PCN-268775

Product Change Notice

New orange Die replacement for Lead frame Seven Segment Display.

Part identification:

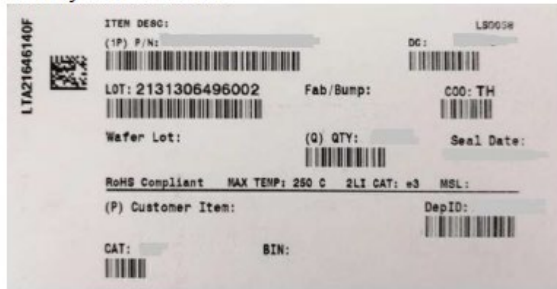
Label for current die

Label for new die

Prefix "E" will be added to the Lot number
